1	P1	PRELIMINARY ISSUE	7/5/14
REV No	REV MARK	REVISION DESCRIPTION	REVISION DATE
<b>elitemetalcraft</b>			
DRAWING TITLE		A1_GA_DRAWING	
CONTRACT		SO	
MODELLED BY		ISSUE DATE 00.00.0000	
CONTRACT NO		SCALE 1:20	
DRAWING No		REVISION No. 1

3d

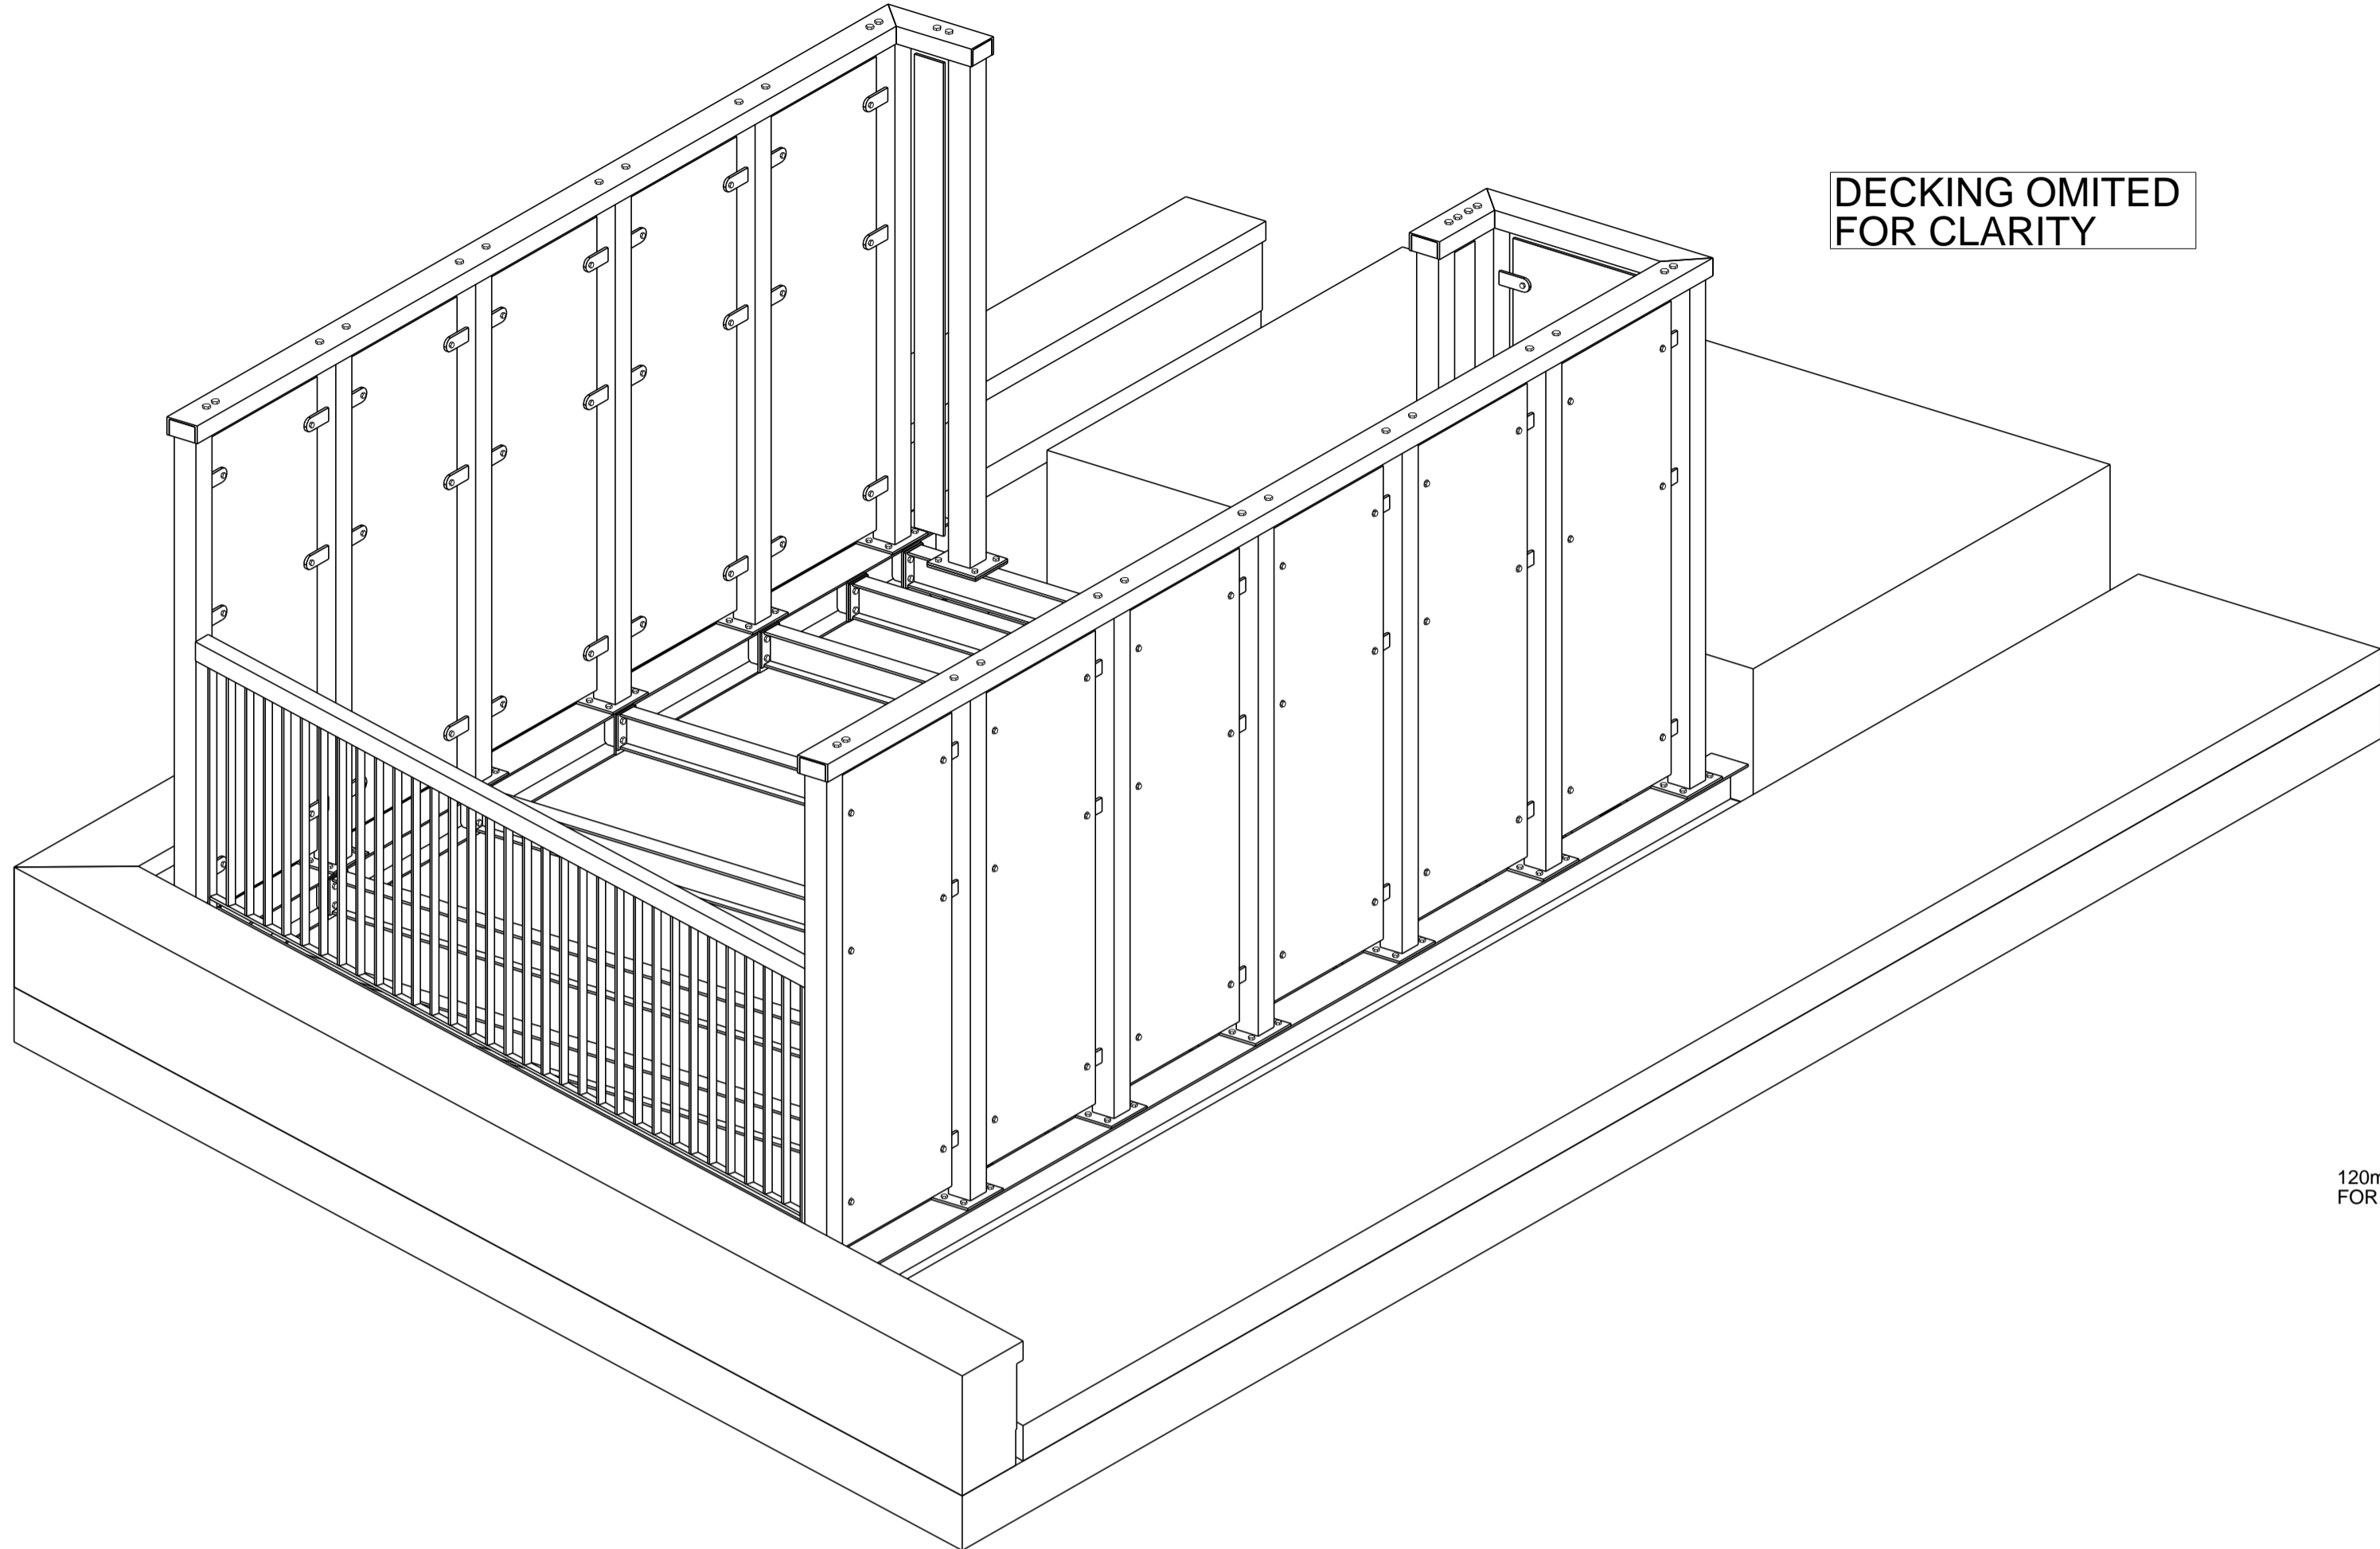
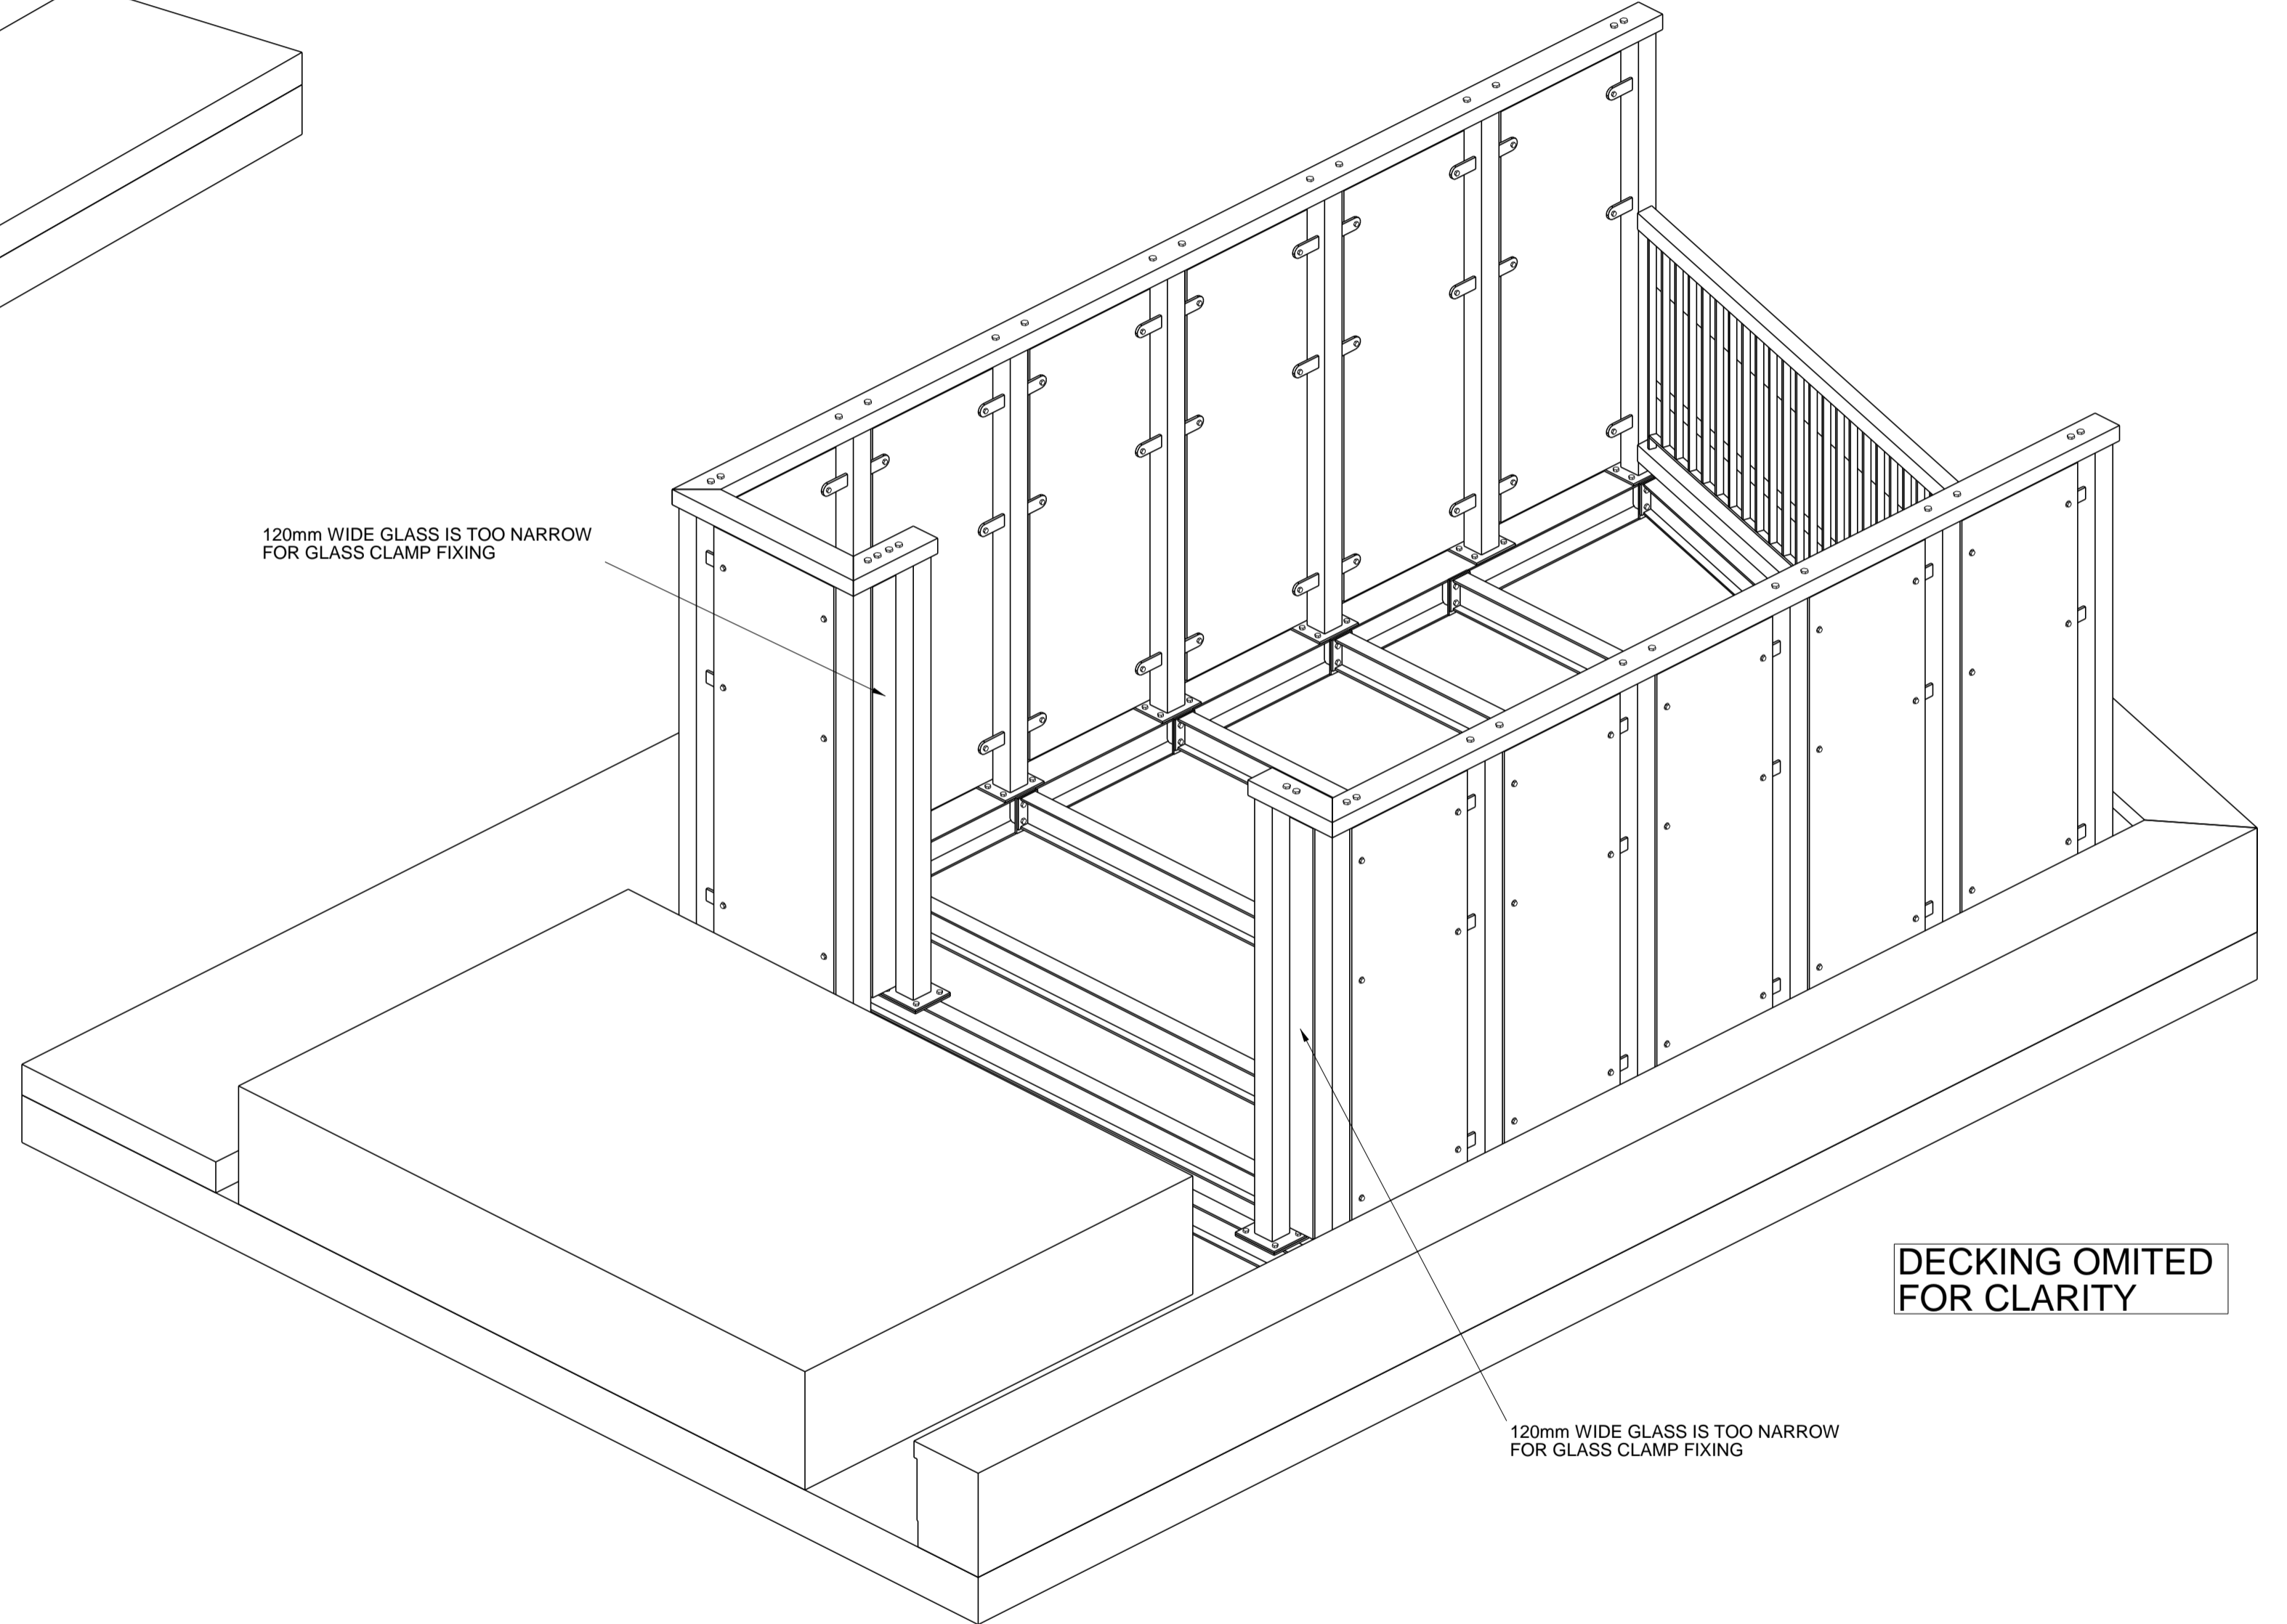
120mm WIDE GLASS IS TOO NARROW FOR GLASS CLAMP FIXING

120mm WIDE GLASS IS TOO NARROW FOR GLASS CLAMP FIXING
